Docket No.: 0951-0135PUS1 Application No. 10/800,709

Amendment dated March 21, 2006

Reply to Office Action of December 21, 2005

Title: ANTENNA APPARATUS AND ELECTRONIC EQUIPMENT

ANNOTATED SHEET

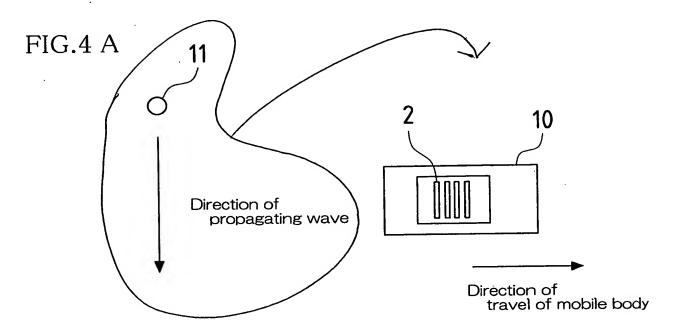
Fig. 4A has been objected to. It is noted that the arrow extending from the broadcast

tower 11 is intended to generally show the direction of wave propagation since the mobile body

10 is moving. Fig. 4A has been revised to show the mobile body 10 in a position below the

The attached sheet of drawings includes changes to Figure 4A. Figure 4A has been

amended to show the wave propagating down the page toward the antenna system. Accordingly,

the portion of the figures to the left in the original Figure 4A has been moved above the mobile

body.
